WORKSESSION #2
Design Review Board Case #2019-0001
WMATA Building - Block 15A / 2395 Mill Road

Block 15A – DRB Work Session #2

**RE: DSUP #2018-0028
2395 Mill Road
Narrative to Accompany Revisions to DRB Meeting #2 Submission Documents of May 21,
2019**

SHEET C6.00

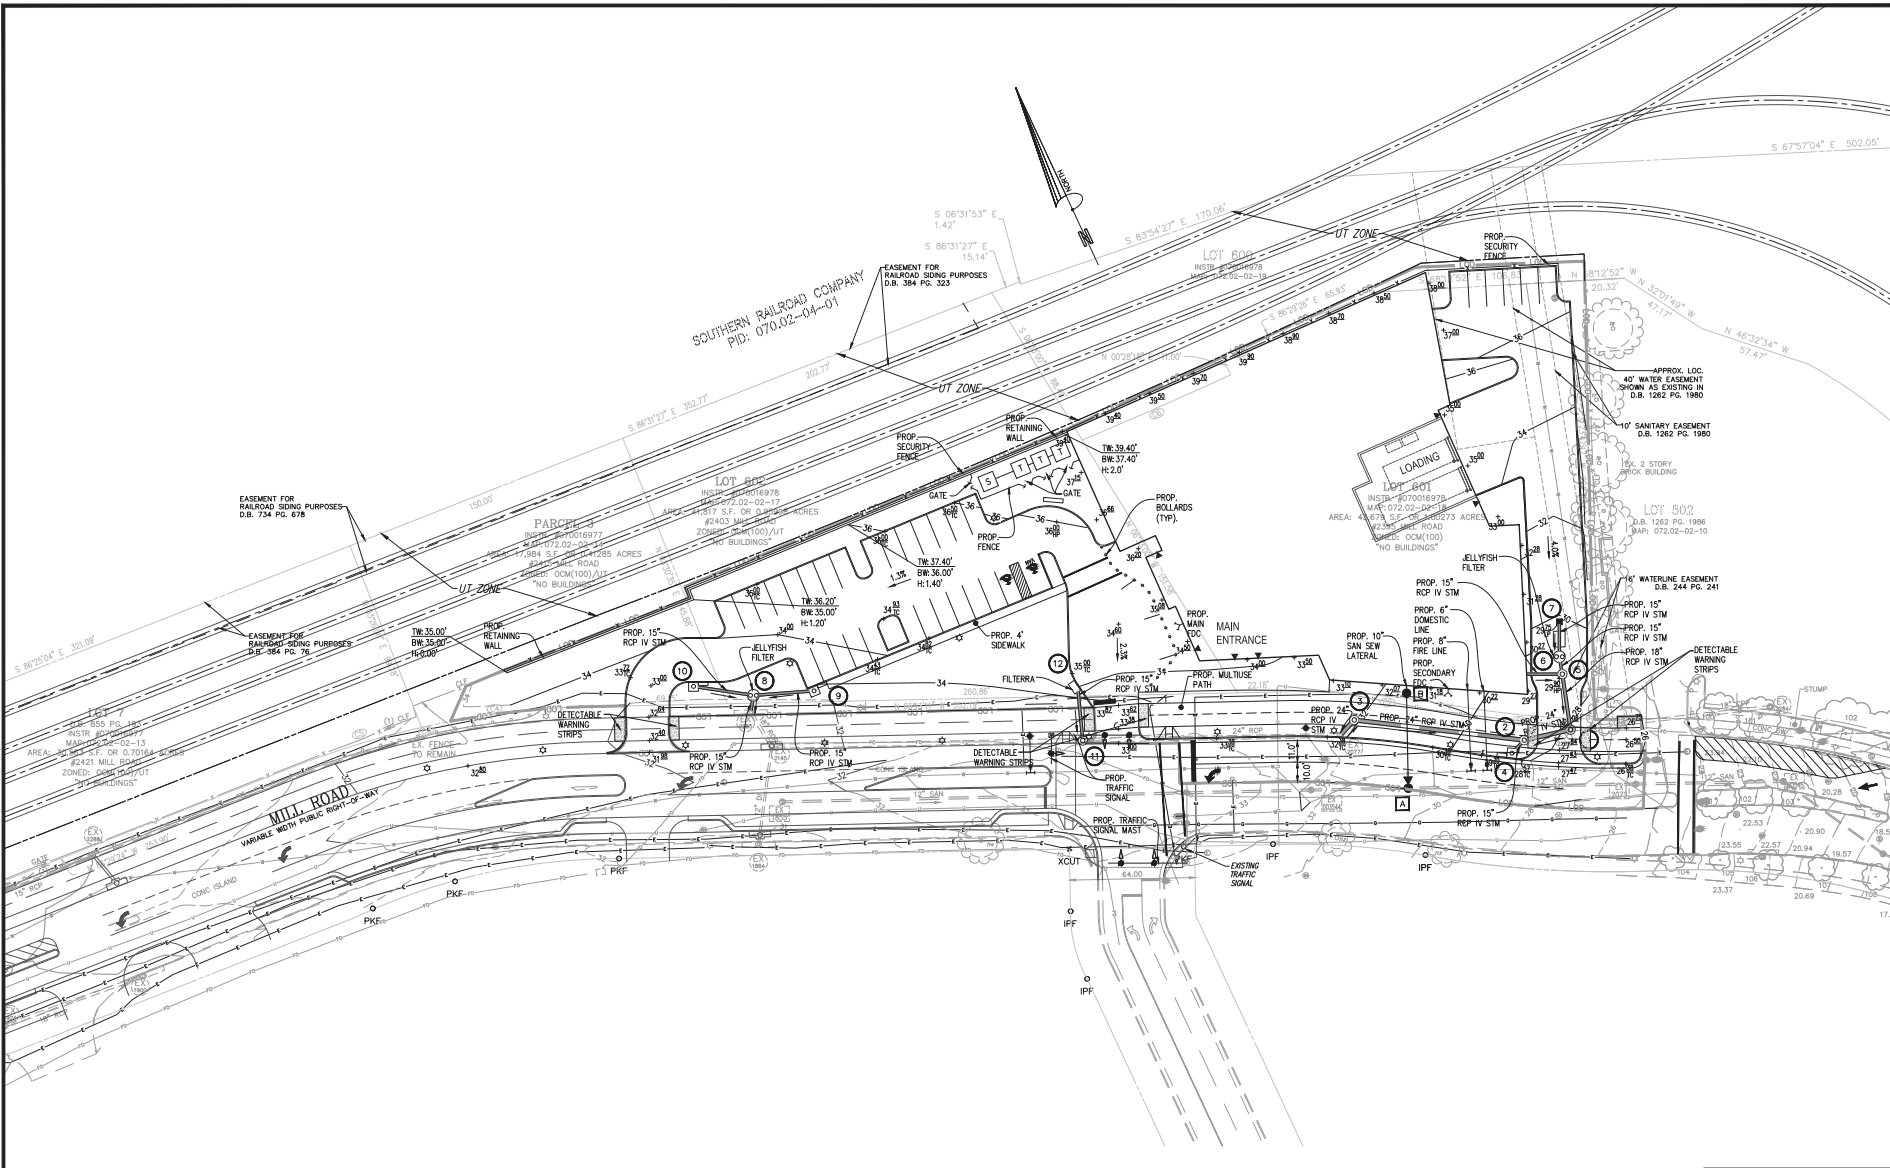
The applicant continues to request a driveway at the western most side of the property into the surface parking lot. The applicant has indicated that establishing the driveway at this time would not only address circulation in and out of the parking lot, but would also provide access to a future second building on the property. While the foresight is appreciated, a second building is not proposed at this time and the applicant has not provided any indication of when a second building would be constructed. The existing site design results in two new driveways and curb cuts off Mill Road, one of which is the driveway to the main parking structure for the building which would be a right in-right out driveway, and staff does not see the necessity for a third driveway on the property. Two driveways appear excessive for a small, 28-space surface lot intended for customers and clients and use of the lighted intersection of Mill Road and Mandeville Lane would provide better traffic efficiency. A reduction of driveways would decrease the number of conflict points along Mill Road, particularly with the multi-use trail. City Traffic engineers discourage more than two curb cuts for any new developments and ask that designer provide creative, efficient vehicle access alternatives. As such, staff continues to request this western most driveway be eliminated with the proposed plan.
